Sundry Notices and Reports on Wells

8. Well Name & Number
Carson SRC #101S9. API Well No.
30-039-27577

The BOP configuration has been revised for the subject well according to the following and attached diagram:

Figure #4
Cavitation Rig
BOP Configuration
2,000 psi Minimum System

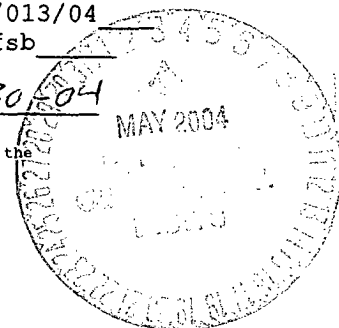
From surface to 7" TD - a choke manifold will be installed in accordance with Onshore Order No. 2 (Reference Figure #3). When the cavitation completion rig drills the production hole, the completion rig configuration will be used (Reference Figure #4).
